## **REMARKS**

In the Office Action, the Examiner rejected Claims 1-30, which are all of the pending claims, under 35 U.S.C. §103 as being unpatentable over the prior art, primarily U.S. Patent Application publication no. 2002/0116371 (Dodds, et al.) and U.S. Patent 6,604,100 (Fernandez, et al.). In particular, Claims 1-4, 8, 10, 13, 14, 17, 19, 20 and 27-30 were rejected as being unpatentable over Dodds, et al. in view of Fernandez, et al; and Claims 5-7, 9, 11, 12, 15, 16, 18, 22, 23, 25 and 26 were rejected over Dodd, et al. in view of Fernandez, et al. and further in view of U.S. Patent publication no. 2003/0120665 (Fox). Claim 21 was rejected as being unpatentable over Dodd, et al. in view of Fernandez, et al. and further in view of U.S. Patent publication no. 2003/0212660 Kerwin), and Claim 24 was rejected as being unpatentable over Dodd, et al. in view of Fernandez, et al, Fox and Kerwin.

**AMENDMENTS TO THE DRAWINGS:**

FIG. 2

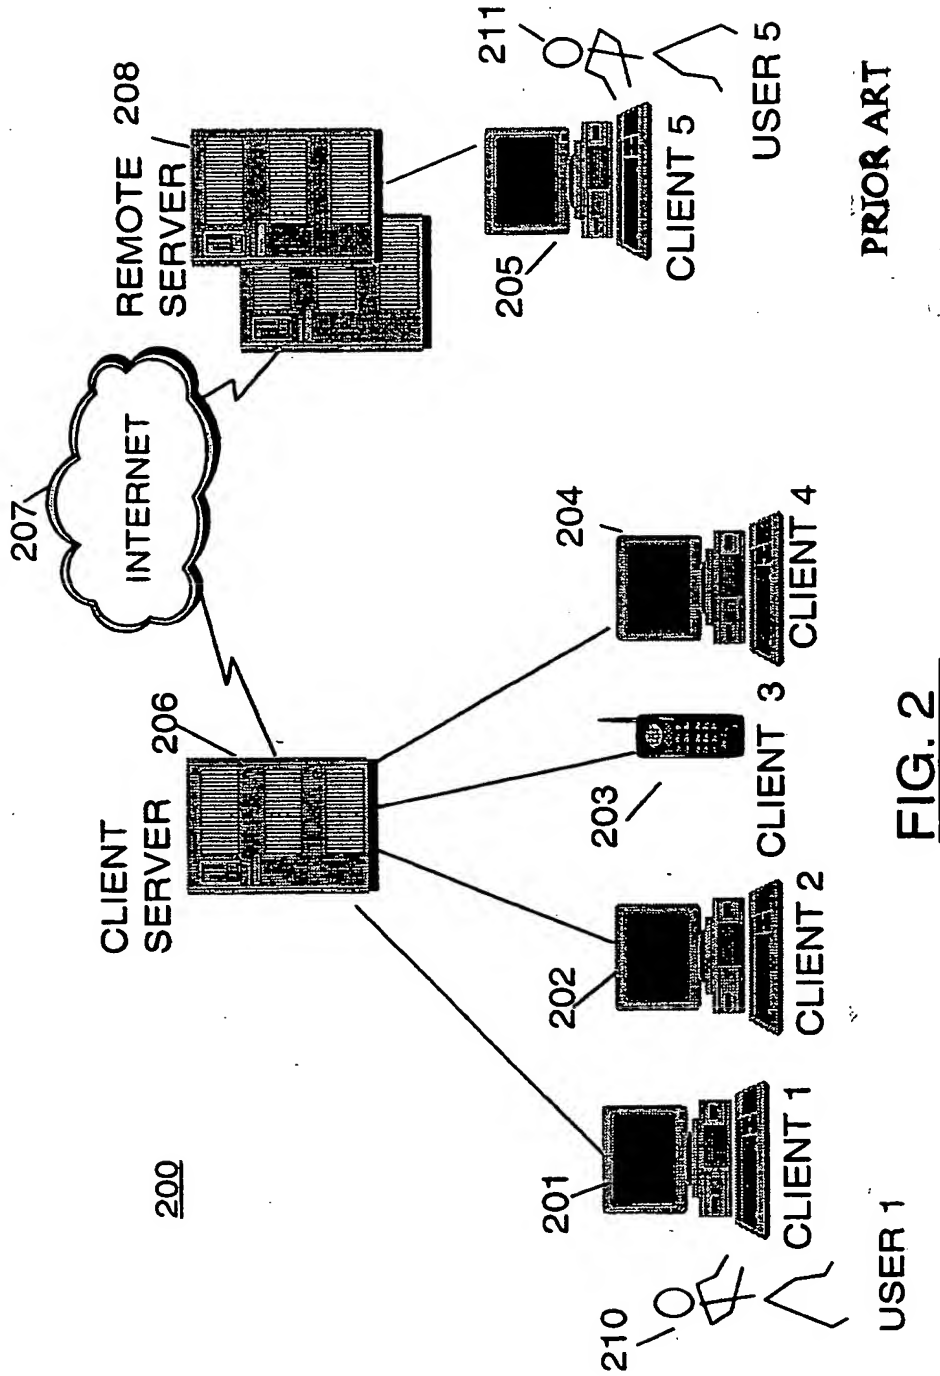
In objecting to the drawings, the Examiner noted that Figures 1 and 2 should be designated as "Prior Art," and that in Figure 3C, reference characters "326" and "327" have both been used to designate a network. The Examiner also noted that several reference characters shown in Figures 1, 2, 3C, 4, 6, 7, 8B, 10A, 10B and 10C are not mentioned in the specification.

In response, Applicants are submitting herewith corrected Figure 1 and 2, in which both of these Figures are labeled as "Prior Art." In addition, the specification is being amended to add the missing reference numbers from the Figures, care being taken to avoid adding new matter.

Please replace original Figures 1 and 2 with the corrected Figures 1 and 2 submitted herewith.

PRIOR ART
